United States Nuclear Regulatory Commission Official Hearing Exhibit		
In the Matter of: POWERTECH USA, INC. (Dewey-Burdock In Situ Uranium Recovery Facility)		
	ASLBP #:	10-898-02-MLA-BD01
	Docket #:	04009075
	Exhibit #:	APP-016-D-00-BD01
	Admitted:	8/19/2014
	Rejected:	
	Other:	
	Identified:	8/19/2014
	Withdrawn:	
	Stricken:

### **Background Radiological Characteristics**

Figure TR RAI 2.9-1-2: Dewey-Burdock Wind Direction Distribution

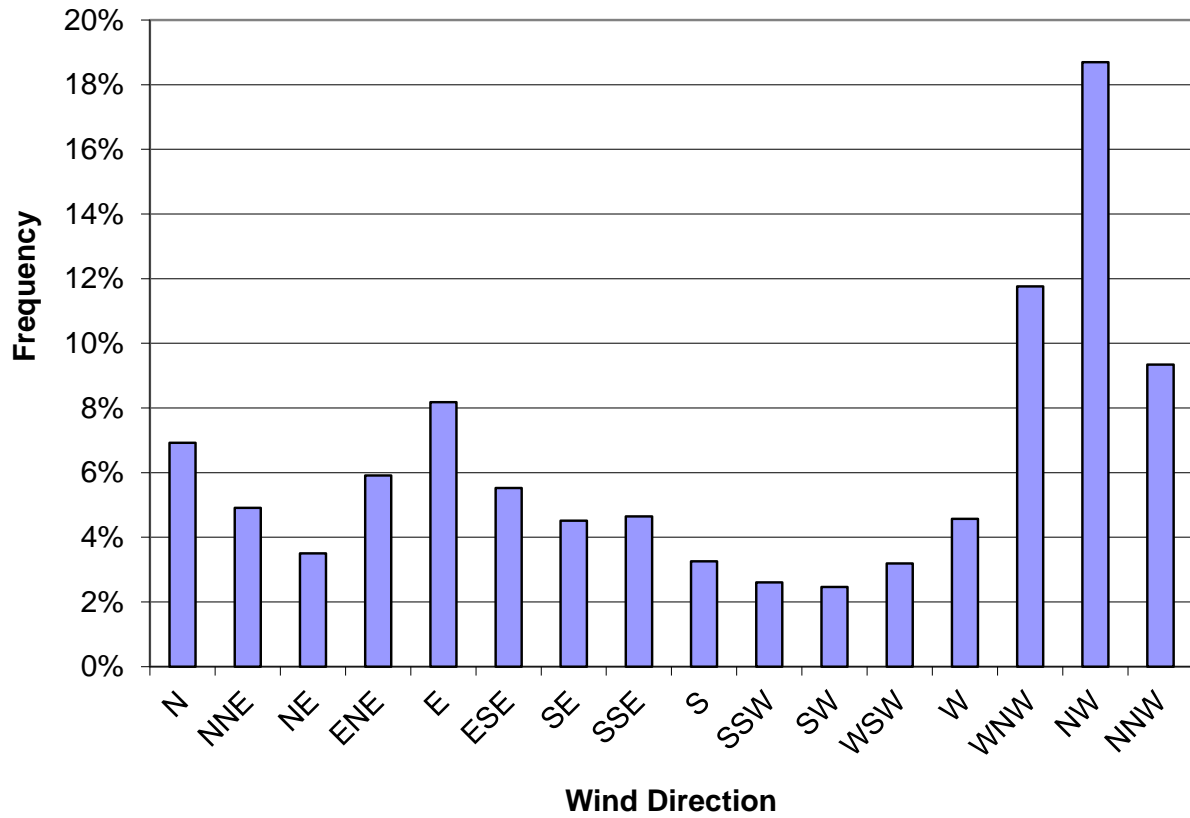
***Regulatory Guide 4.14 provides criteria for determining air particulate sampling locations. NRC staff cannot locate the applicant's criteria for determining air particulate sampling locations in section 2.9 of the TR. Consistent with Regulatory Guide 4.14 and NUREG-1569, Acceptance Criterion 2.9.3(1), provide the criteria used to establish air particulate sampling locations or indicate where this information can be found in the TR.***

Factors 1-5 are identical to the air particulate sampler siting criteria contained in Regulatory Guide 4.14. Factors 6 and 7 were added to account for site-specific conditions. Table TR RAI 2.9-1-1 compares the air monitoring station locations suggested by Regulatory Guide 4.14 to those established for the site. The locations of the air monitoring stations are shown on Figure 2.9-8 (p. 2-325) of the TR and on Figure TR RAI 2.9-1-1.

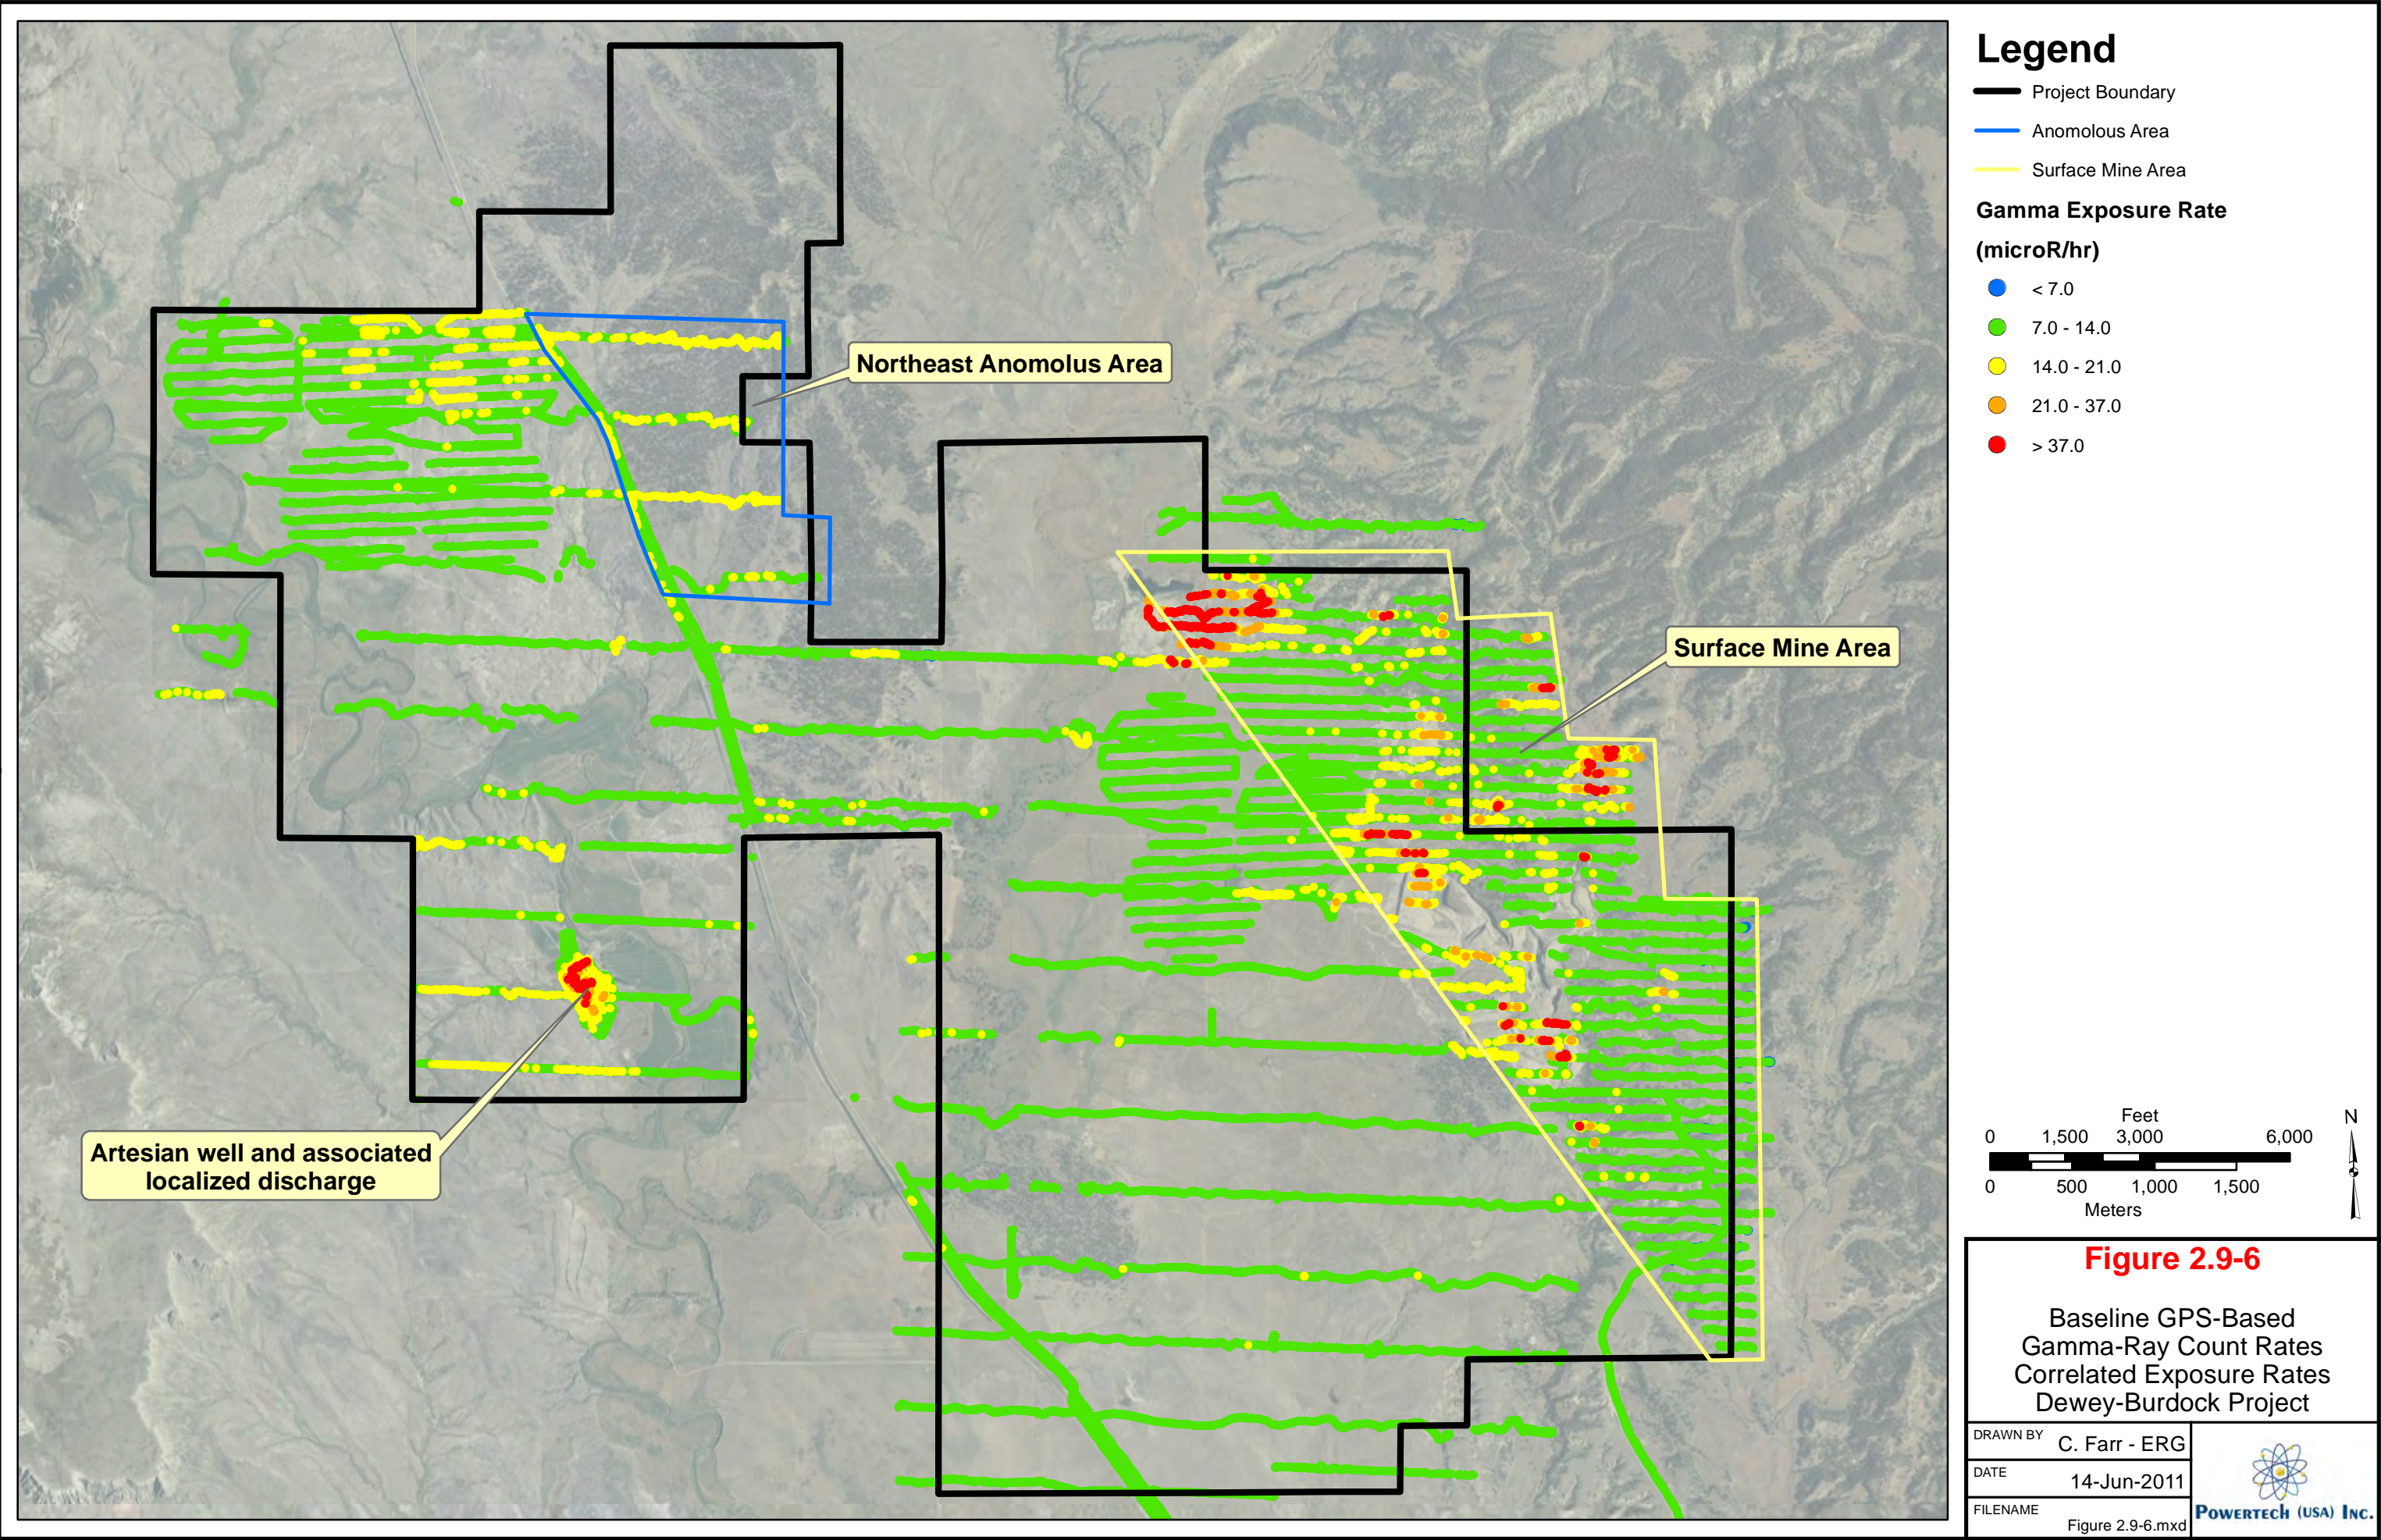
*Please provide the following information related to the predicted site-wide exposure rates discussed in Section 2.9.2.2.2 of the TR:*

TR Figure 2.9-6 was intended for informational purposes only, to qualitatively evaluate the relative spatial distribution of exposure rates across the project area. No interpolation of the data was performed other than to group the data by category using ArcView GIS. The grid block exposure rates presented on Figure 2.9-6 reflected the average of all predicted exposure rates, as calculated from the gross gamma-ray count rates that fell spatially within each 700 x 700-foot grid block boundary. With a 500-meter gamma survey transect spacing used throughout most of the site, approximately 40 percent of the grid blocks have no gamma readings (a null value when calculating the exposure rate). The GIS analysis of these grid blocks interpreted no gamma-ray count rates as a zero value instead of a null value, which resulted in the incorrect display of a zero value. No interpolation or other method to spatially predict gamma exposure rate within the project area was used.

This will be clarified in the revised TR. Figure 2.9-6 of the TR has been revised and Figure 9-3 of Appendix 2.9-A will be revised to only show exposure rate estimates from points where gamma survey data were collected. The revised Figure 2.9-6 is provided below.

**Figure TR RAI 2.9-32c-1: Linear Regression of Gamma Count Rate Data and PIC Measurements, Including the 95% Confidence Interval**

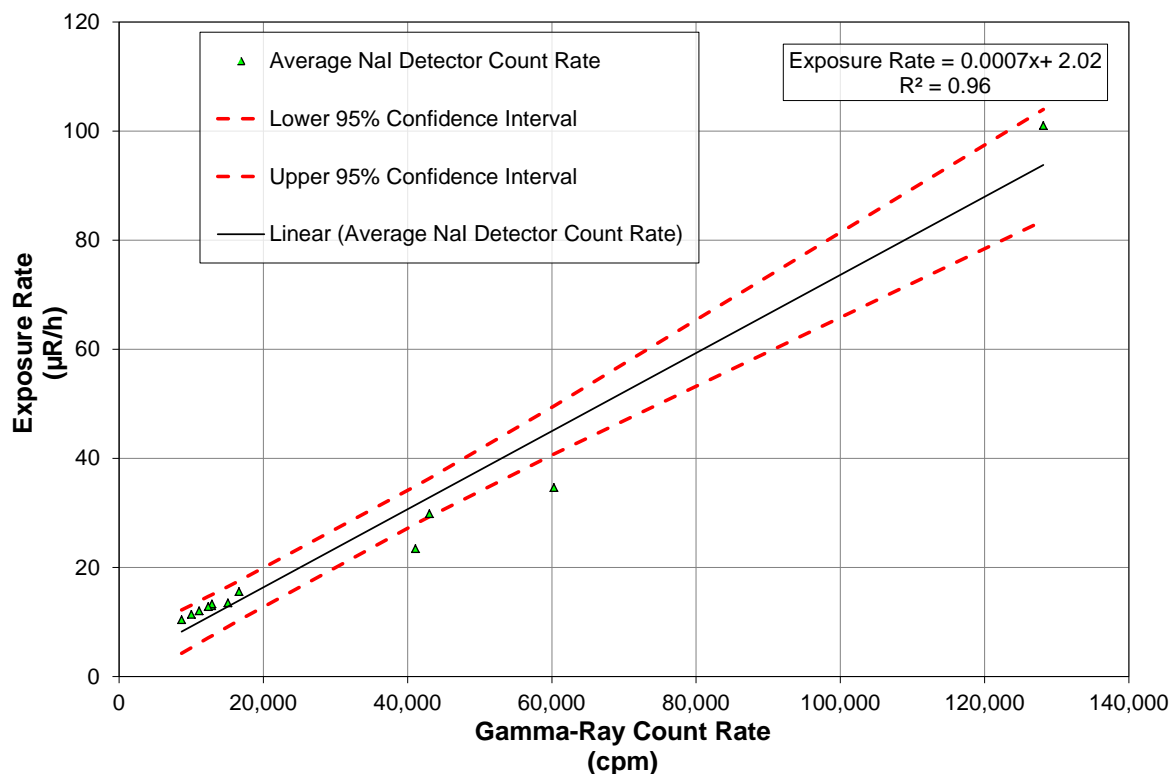
*c. Error estimates of the data presented in Figure 2.9-6, Predicted Site-Wide Exposure Rates, Grid Block Averages, in the TR.*

The error estimates associated with the data on updated Figure 2.9-6 are based on the linear regression correlation of the gamma count rate data and PIC measurements. The 95 percent confidence interval of the regression line is shown in Figure TR RAI 2.9-32c-1 below. For predicted exposure rates near the median gamma count rate, the upper and lower 95 percent confidence limits are within 35% of the predicted value.

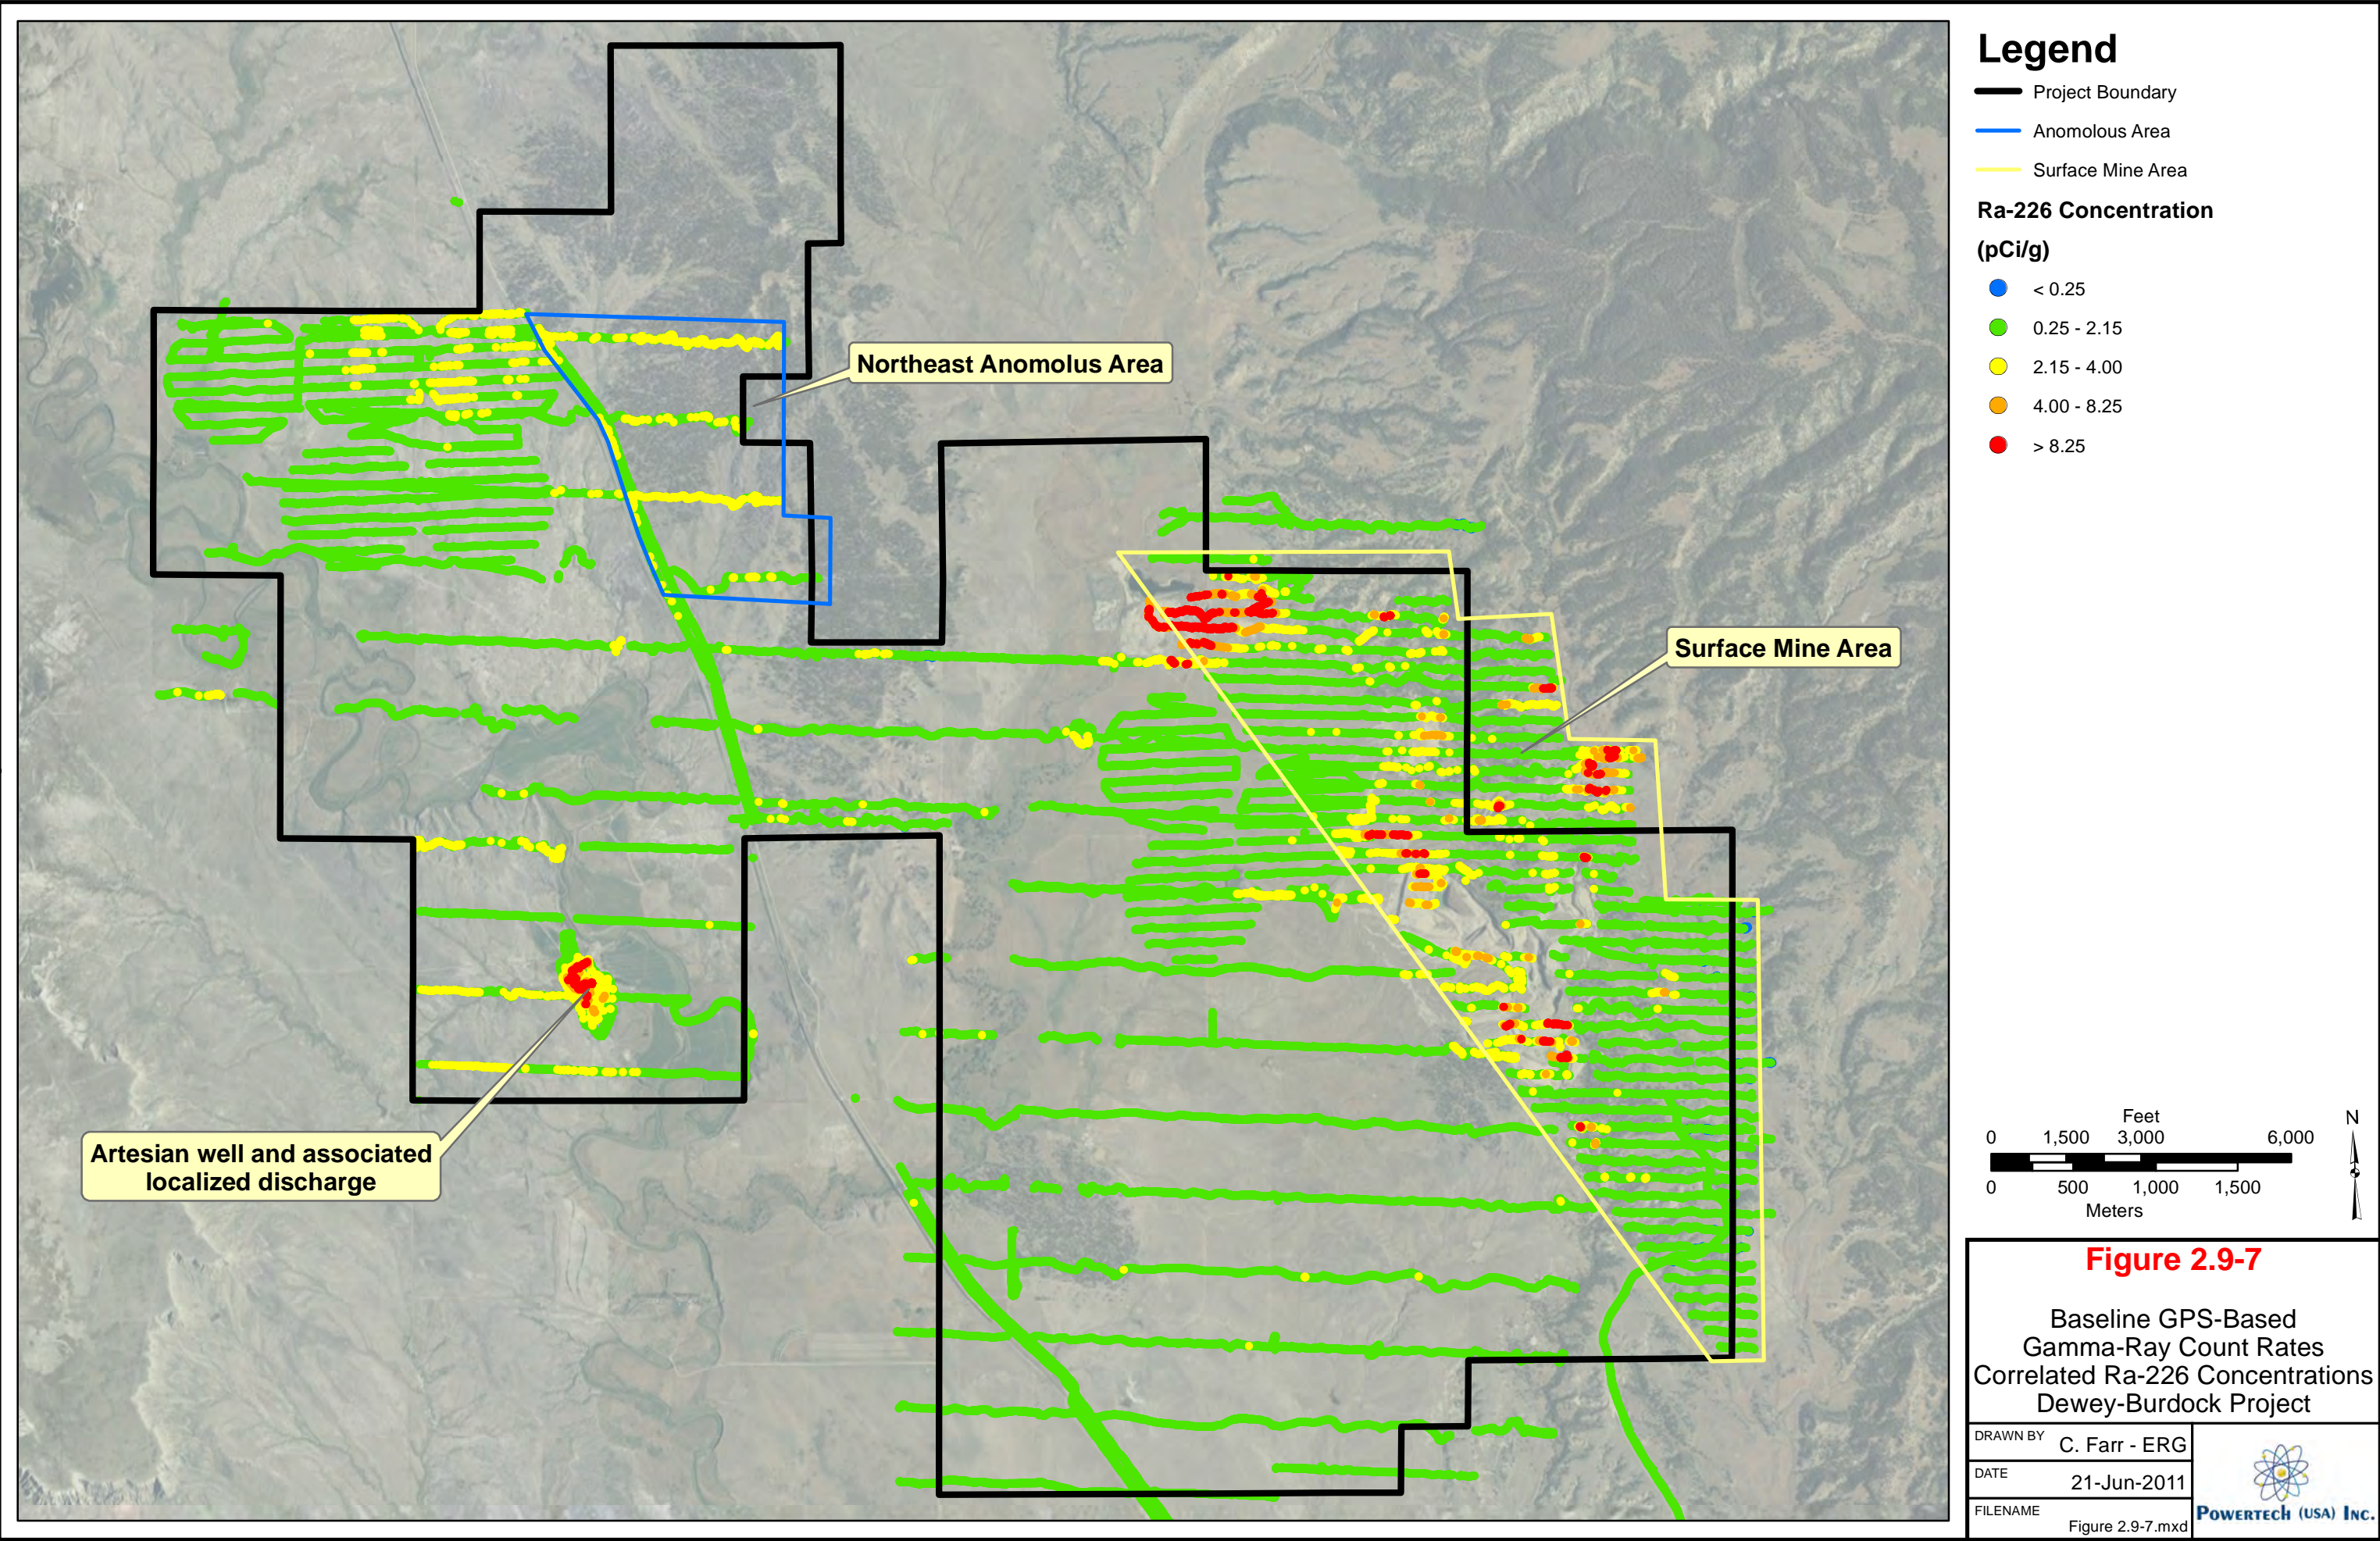
- c. Please provide error estimates of the data presented in Figure 2.9-7, Predicted Site-Wide Radium-226 Concentrations, Grid Block Averages, in the TR. In the response, include a discussion of the various sources of error (e.g., seasonal variability in gamma dose rates, using a regression model with an  $R^2$  (coefficient of determination) value of 0.43, etc.)***

Figure 2.9-7 was intended for informational purposes only, to qualitatively evaluate the relative spatial distribution of Ra-226 concentrations in soil across the project area. No interpolation of the data was performed other than to group the data by category using ArcView GIS. The grid block Ra-226 concentrations presented on Figure 2.9-7 reflected the average of all predicted Ra-226 concentrations, as calculated from the gross gamma-ray count rates that fell within each 700 x 700-foot grid block boundary. With a 500-meter gamma survey transect spacing used throughout most of the site, approximately 40 percent of the grid blocks have no gamma readings (a null value when calculating the Ra-226 concentrations). The GIS analysis of these grid blocks interpreted no gamma-ray count rates as a zero value instead of a null value, which resulted in the incorrect display of a zero value. No interpolation or other method to spatially predict Ra-226 concentrations within the project area was used.

Figure 2.9-7 of the TR and Figure 9-3 of Appendix 2.9-A have been revised to only show Ra-226 concentration in soil exposure rate estimates from points where gamma survey data were collected. Revised Figure 2.9-7 is included below and will be incorporated into the revised TR.

Regarding error estimates for the data presented in Figure 2.9-7, please refer to the responses to TR RAI 2.9-32 (c) and TR RAI 2.9-38(a) and (b). Figure 2.9-7 will be revised and the interpolation eliminated. The error associated with the predicted values is coupled with the error of the regression line. A 95% confidence interval for the regression line used to predict radium-226 concentration is shown in Figure 5-2 of Appendix 2.9-A. The 95% confidence interval across the range of typical gamma count rates spans approximately 2 pCi/g. Provided future gamma count rates are collected using similar instrumentation and during a similar seasonal period as the existing data, little seasonal variability would be introduced. If soil moisture conditions are much different when collecting future gamma count rate data, new correlations to radium-226 concentrations in soil will be established for the specific condition.
